**HABERNETZLE TOWNHOMES - 110 N 39TH ST**

**PROJECT NUMBER 3012414**

**STREAMLINED DESIGN REVIEW**

**SEPTEMBER 20 2011**

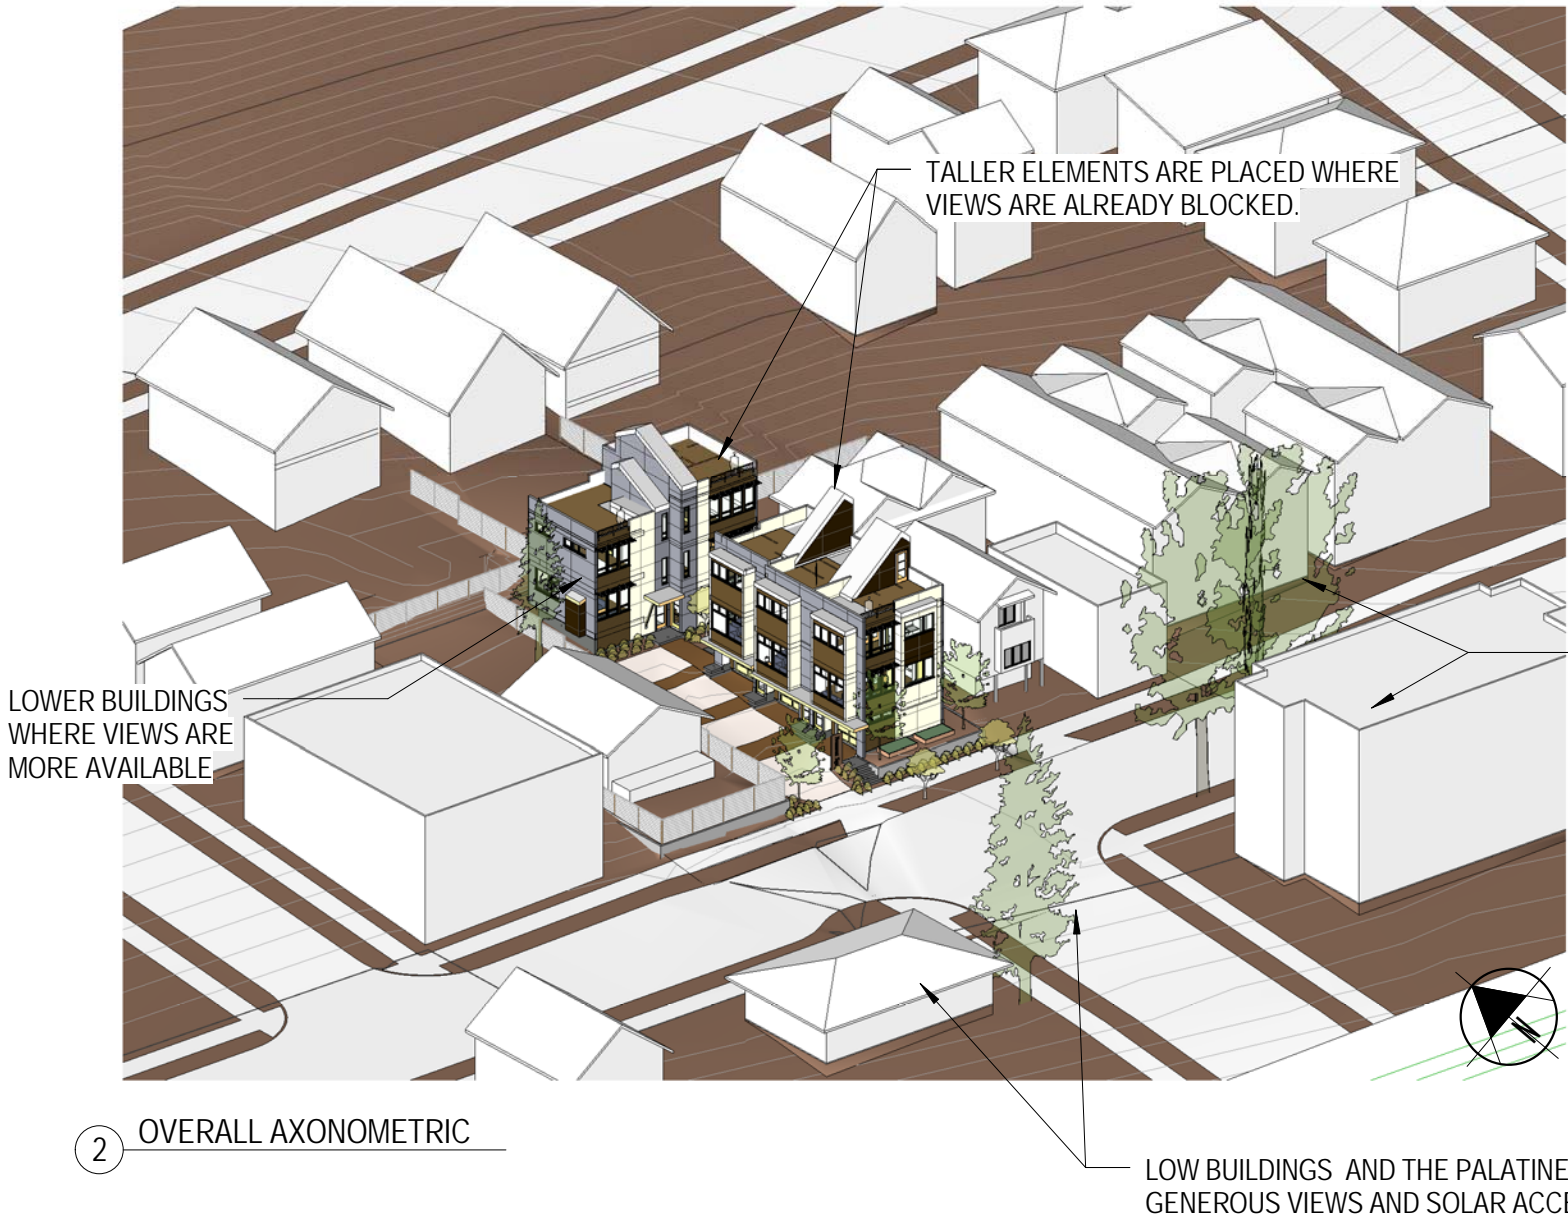
A-1 Respond to site characteristics; A-5 Respect for adjacent sites:

DPD Early Design Guidance: Break down massing to create view corridor for the single family neighbor above.

Response: The neighborhood slopes to the south toward the ship canal, providing regional views. This project will be taller than the single-family houses behind it and will affect the views of the neighbors directly behind to the north. Their existing views to the SE are obscured by large trees and an existing apartment building. The massing of the project is designed to put the tallest elements on the east side of the site, where the views are already compromised. One story is dropped off of unit 5 in order to suppress its height & preserve the west side of the site as a view corridor.
